TO:**Bidders****PROJECT:****Unicorn Daycare – Trail, BC Project Number 23-06****TENDER ADDENDUM #3**

3 Pages + 22 Page attachment

This Addendum shall be read in conjunction with and considered as an integral part of the Contract Documents for the above project; revisions supersede the information contained in the original drawings, specifications or previously issued Addendum.

**Landscape Materials
Plan**

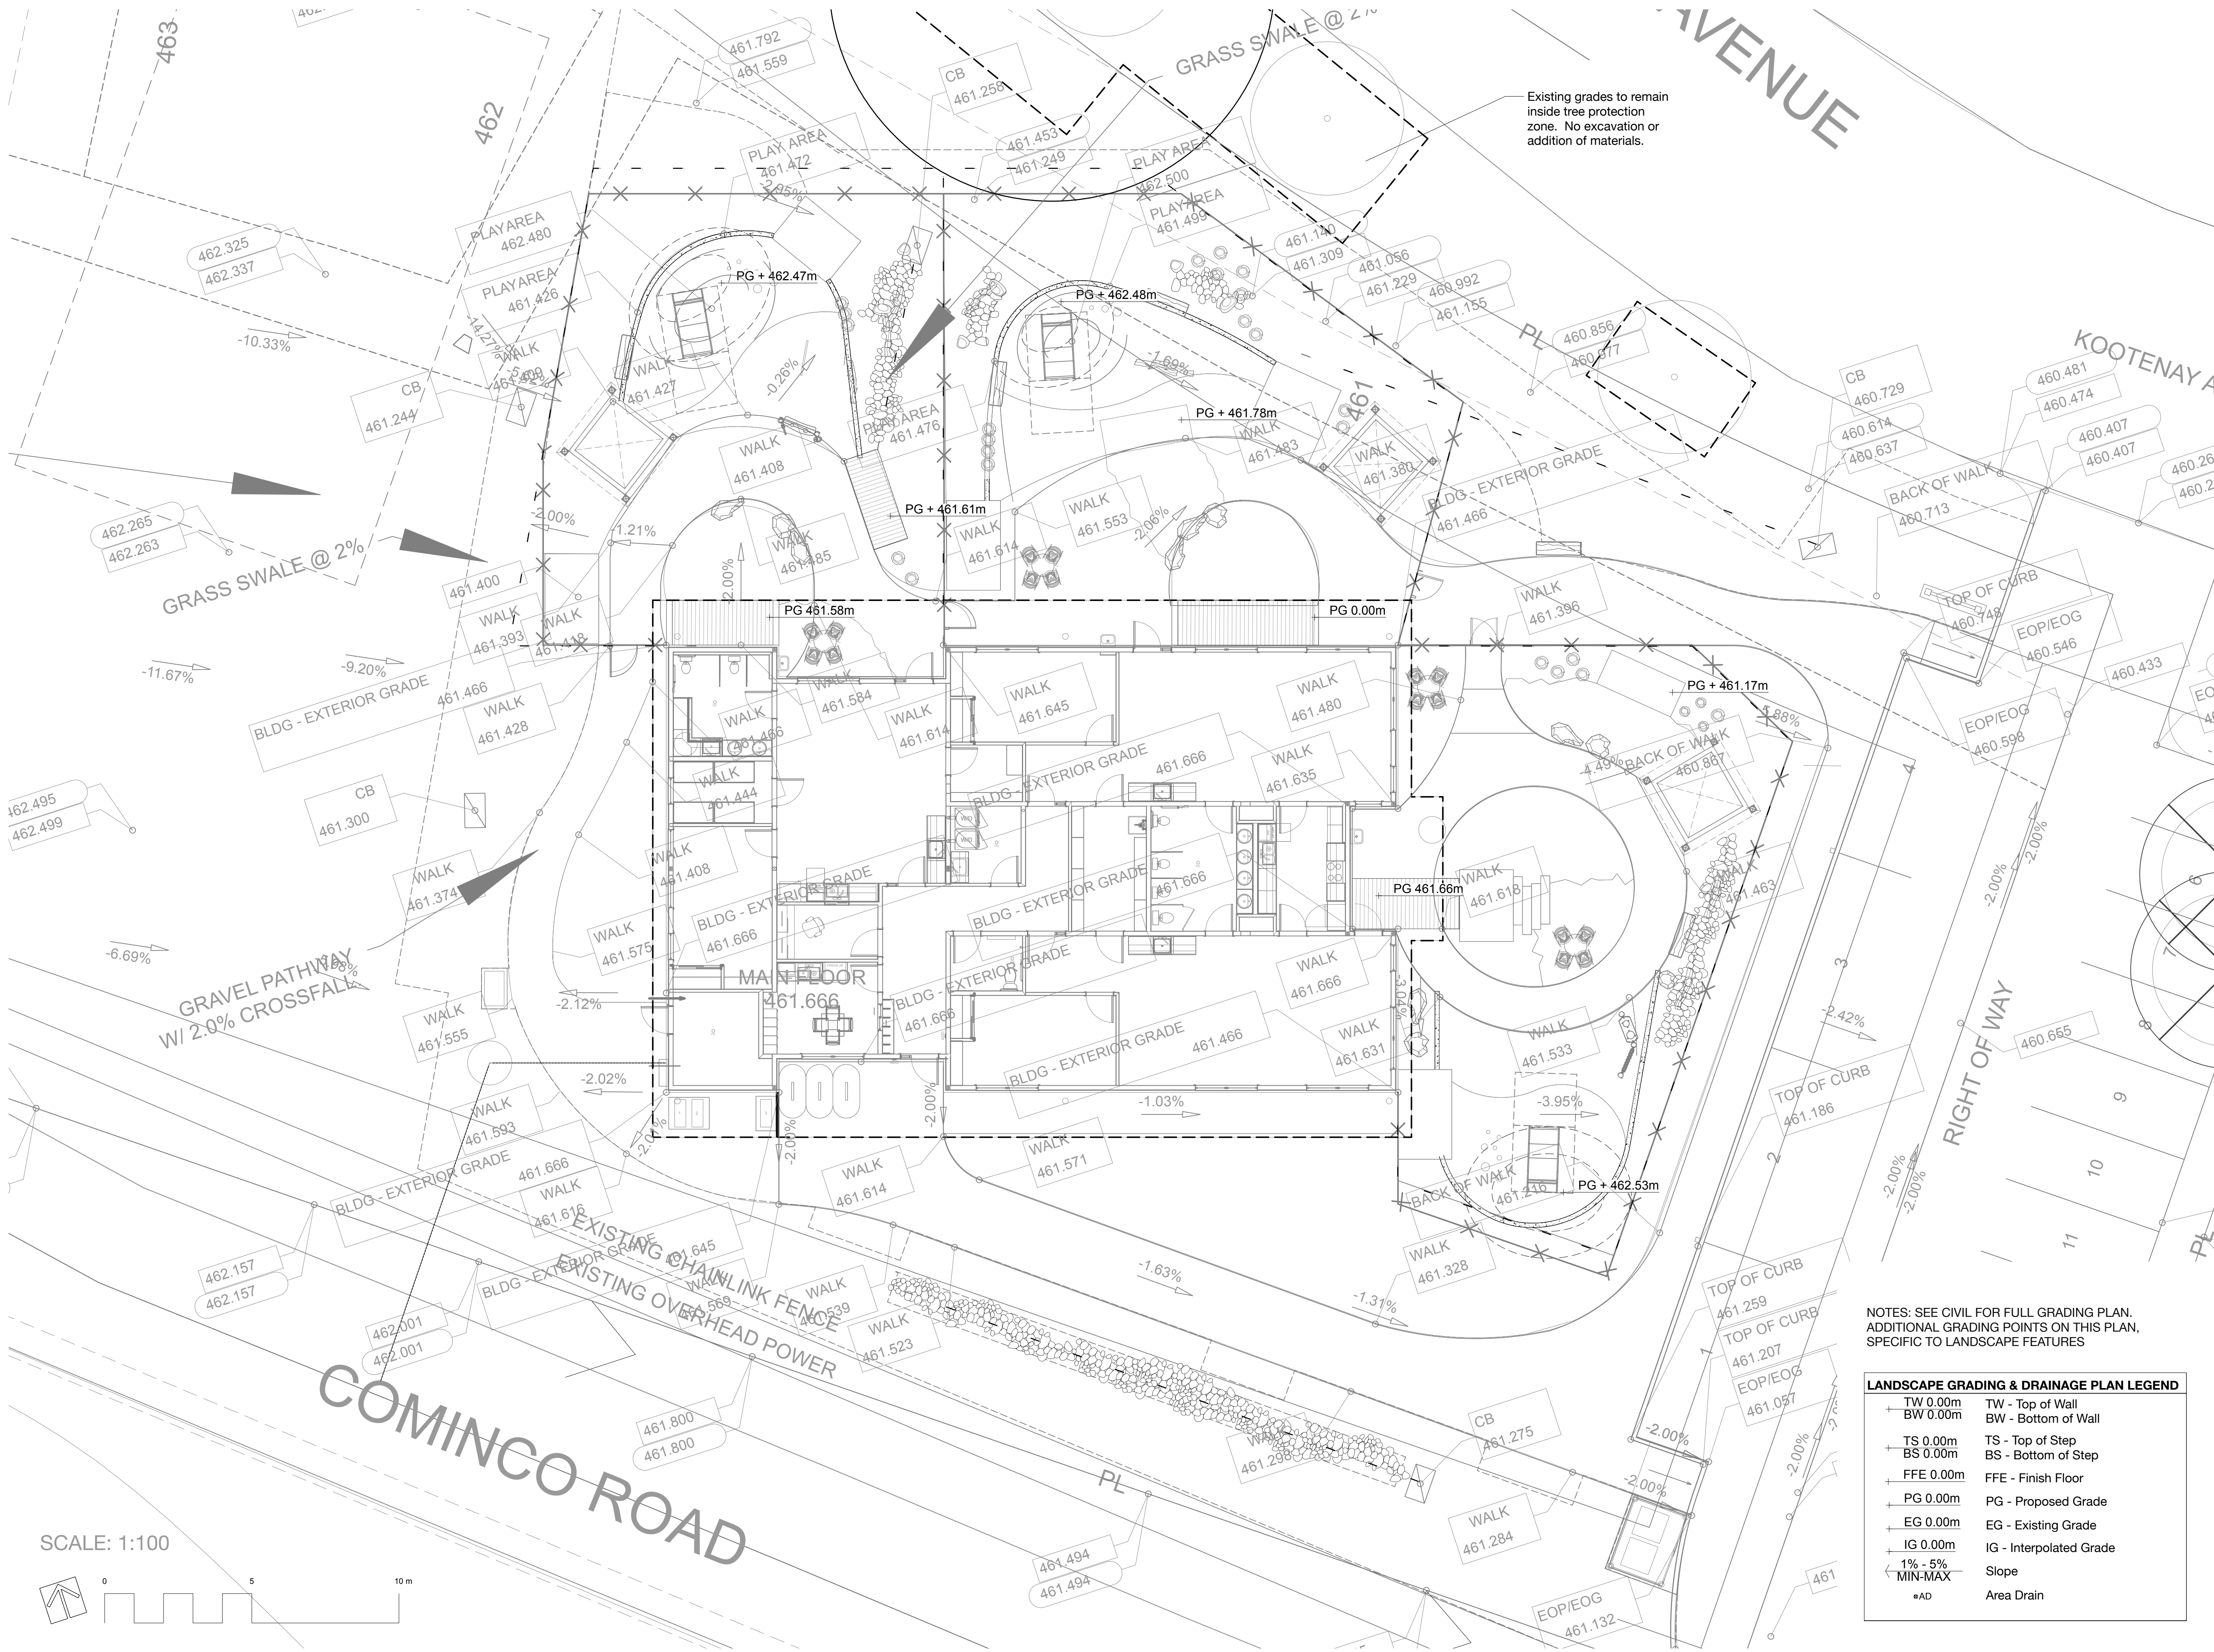
6. L0.1 ACCEPTABLE ALTERNATE: Red cedar is an acceptable alternate for yellow cedar where specified.
7. L0.1 Materials and Furnishings Schedule & L3.0 REVISE:

- F1 Bench: 5 benches required, per plan.
 - F2 Boulders: 11 boulders required, per plan.
 - F6 Log Rounds: 26 log stumps required, per plan.

- P5 Mounds: 3 sets of mounds with hand holds, see 5/L9.3, located where slides are.
- 8. L0.1 & 6/L9.2 REVISE: Boulders to be locally sourced, clean, submit photos for review. Boulders are not required to be basalt.
- 9. L9.5 ADD: note, bridges and platforms to be finished with natural colour stain.

CUT/FILL PLAN

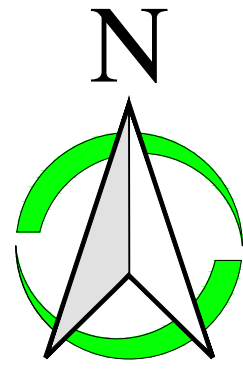
3. CUT/FILL PLAN C12 ADD: Cut/Fill Plan drawing to civil drawing set, see attached.
Note: "Volume surface calculated as the difference between the existing ground surface and the proposed design surface. It does not take into account excavation for utilities, stormwater disposal or footings, nor does it take into account landscape materials such as rubber surfacing. This plan is shown strictly for assistance in tendering and should not be used as a sole source for calculating cut and fill quantities."
See landscape drawings for soil depths for planting and hardscape assemblies. See geotechnical report, structural, and architectural drawings for footing depth requirements. See architectural specifications and Addendum #2 1.5. for Teck expectations for management of contaminated soils.
